TO: SERVICE MANAGER CI      MECHANICS O  
PARTS MANAGER O

No. 90-13

## A. OIL LEAK AT FRONT OF ENGINE

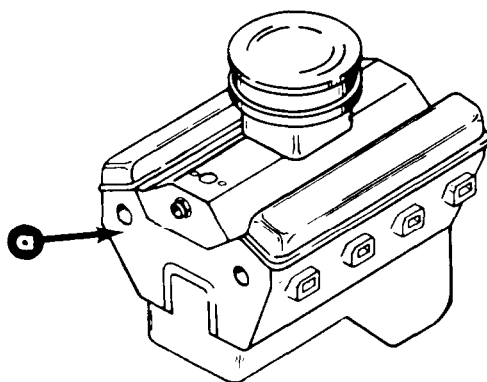
Oil leak at front of engine. May give the false appearance that oil is being blown out of the oil dipstick tube.

The leak is at the oil seal in the front crankcase cover (crankshaft). The original seal was either over-size or out-of-round before it was installed into the cover. In most cases, the cover was damaged when the seal was installed at the factory.

Check engine CODE on front of engine. Repair only the engines that are within the date codes shown below.

a - V6 (Front, Starboard Side, Near Cylinder Head Mating Surface) – T02280KP/KR - T05290KPIKR  
February 28, 1990 to May 29, 1990 build date

If engine has to be removed from the boat to make the repairs, change the front cover.

If seal can be replaced without removing engine from the boat, change the front cover seal only.
